#### **Bryant Development and Review Committee Meeting**

Date: May 29, 2025 - Time: 9:00 AM

#### DRC Staff Comments 5/15/25

#### 1. Springhill Storage Rezoning/ site plan

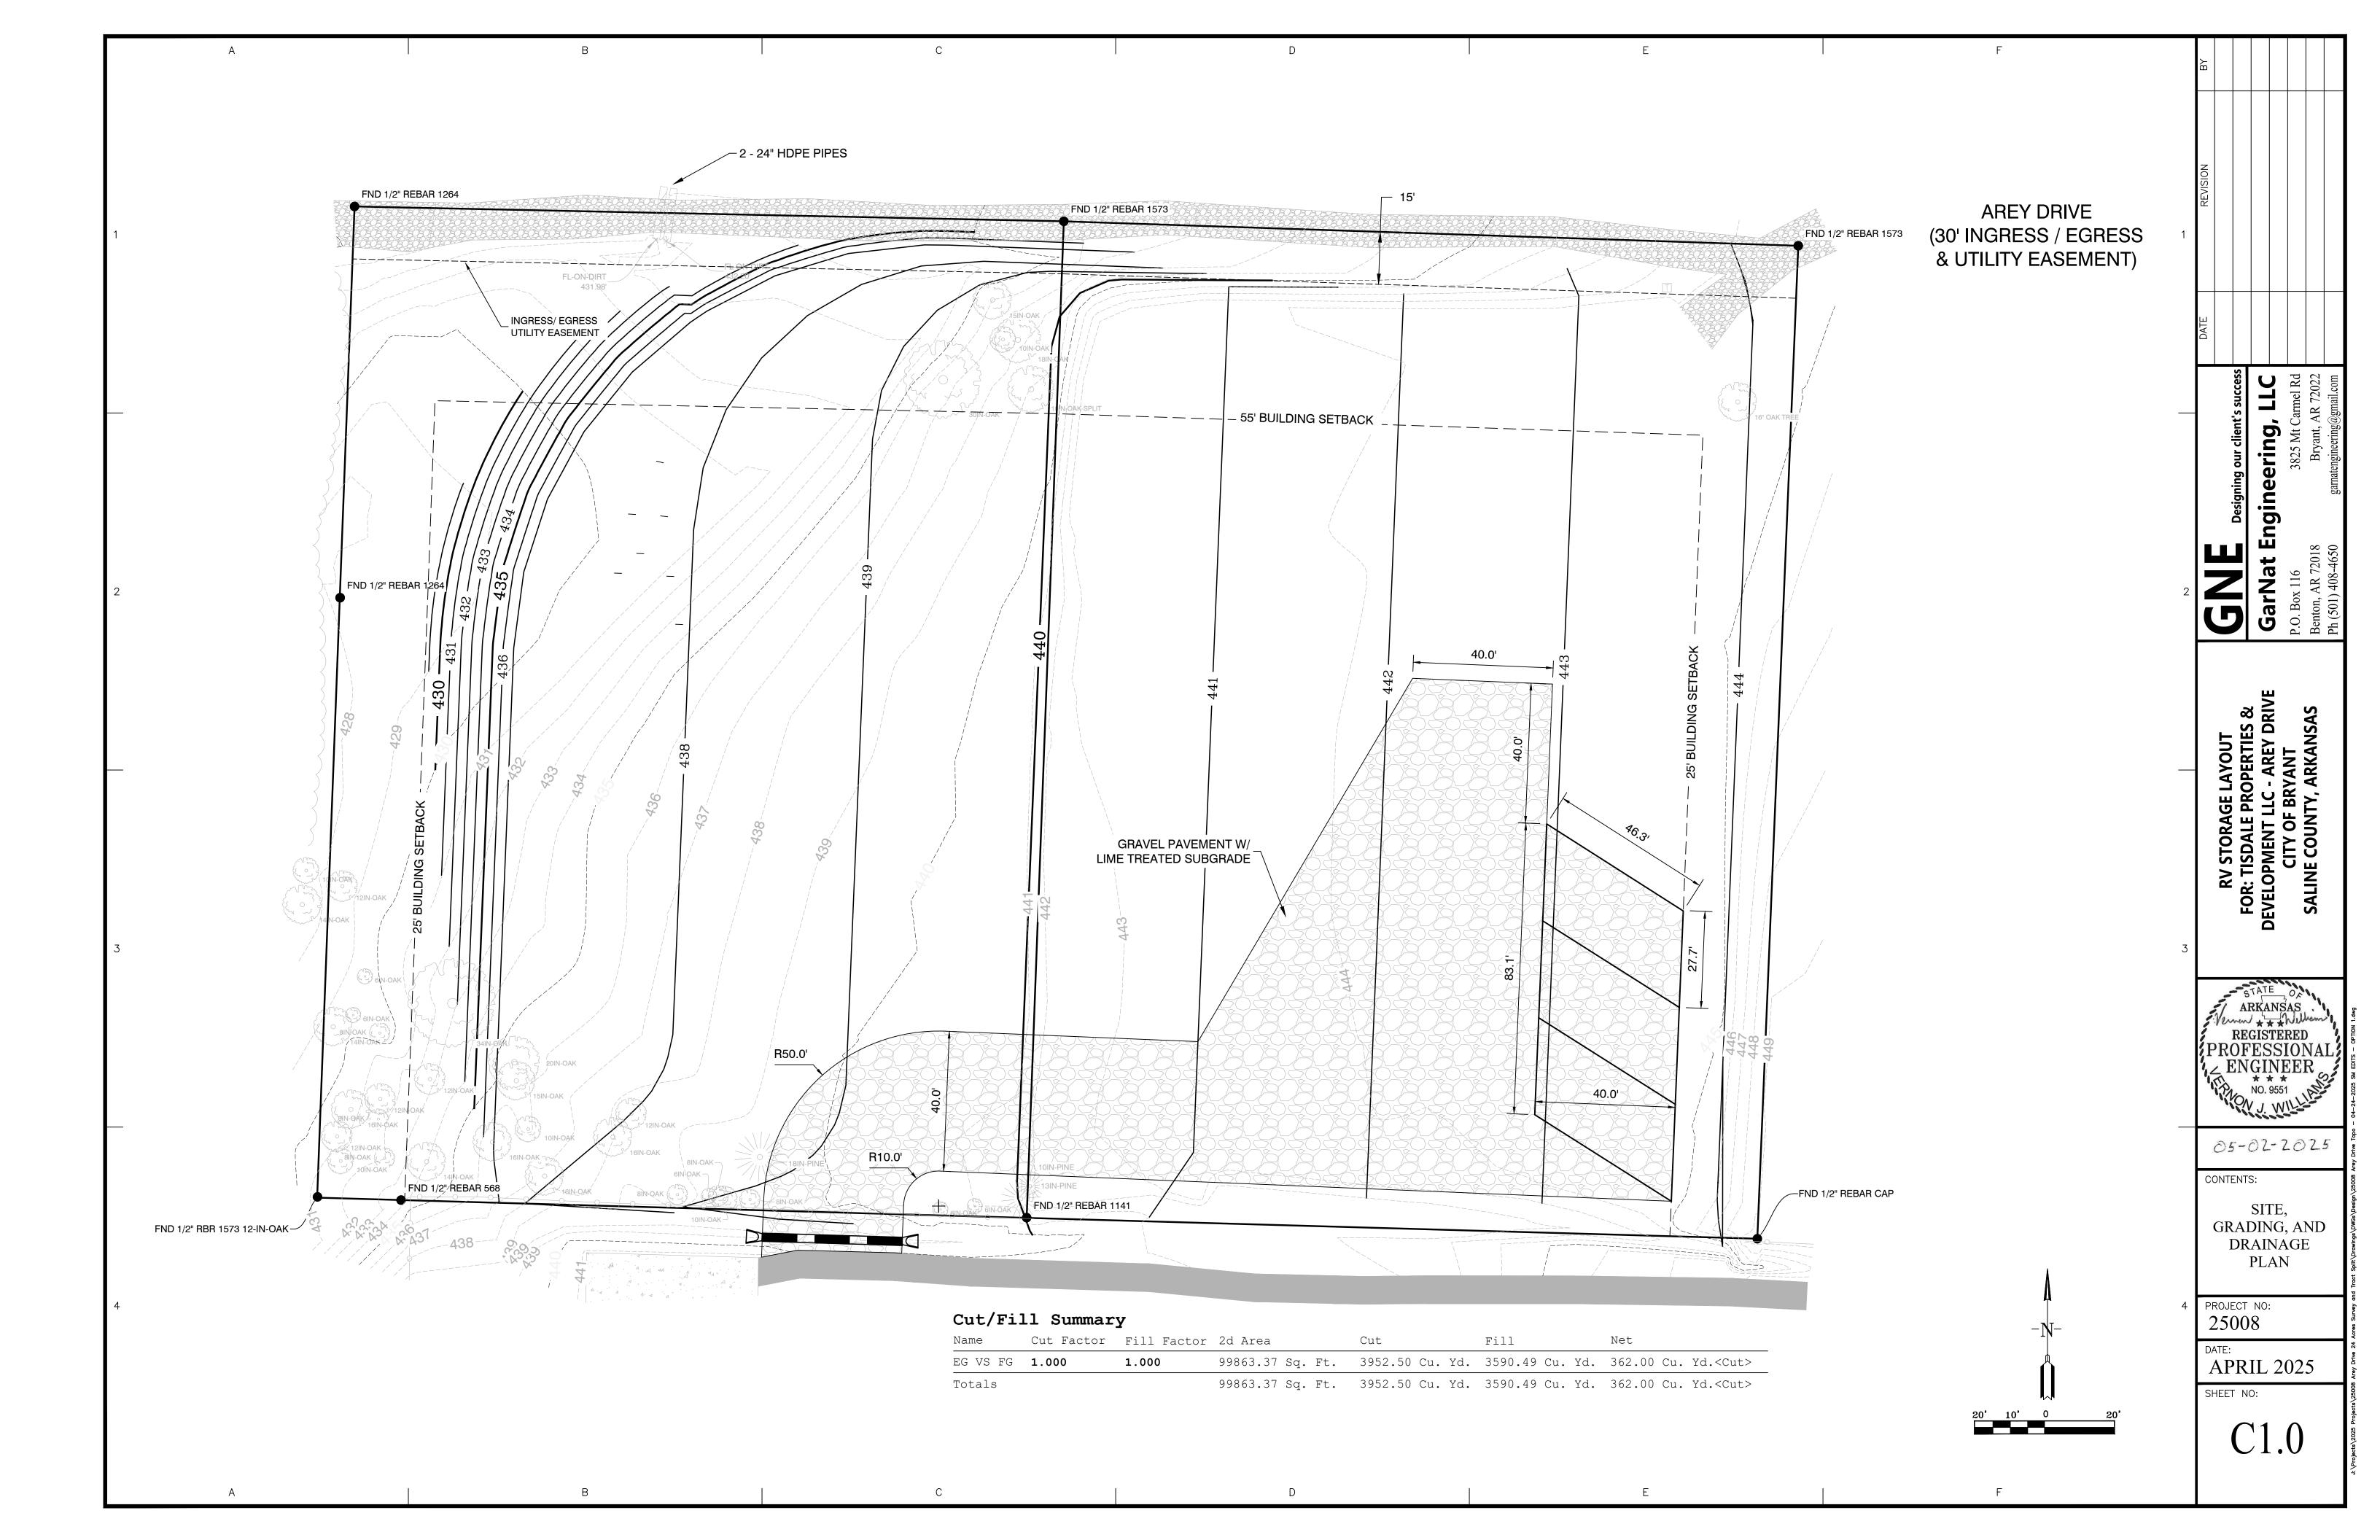
After the DRC meeting today, I looked up the fire hydrant and fire apparatus access requirements. The Arkansas Fire Prevention Code, 2021 Edition is the current applicable code.

- A fire apparatus access road is required to extend to within 150 feet of any portion of the facility. [Vol1, Section 503.1.1] I believe that we comply.
- The fire apparatus access road shall support the imposed load of a fire apparatus weighing 75,000 pounds, [Appendix D102.1] and shall be surfaced to provide all-weather driving capabilities. [503.2.3] Will comply.
- Dead-end fire apparatus access roads in excess of 150 feet need to have an approved area for turning around. [Appendix D103.4, Figure D103.1] Current plans will be adequate if you can show that one of the turnaround conditions is met on the plans. I have attached a copy of Appendix D and I suspect the current site plan has enough room for the 96' diameter culde-sac requirement. We have drawn the limits of a 96' diameter culde-sac on our site plan.

A fire hydrant is required to be within 400 feet of any portion of the facility. [507.5.1] The closest hydrant is about 420 feet south of the lot line in the storage building area. A fire hydrant placed at the entrance to this area will provide adequate coverage under this provision. The previously approved plans included a fire main extension and hydrant. We have added the proposed fire hydrant location to our site plan. We propose to build it as part of this phase of the project.
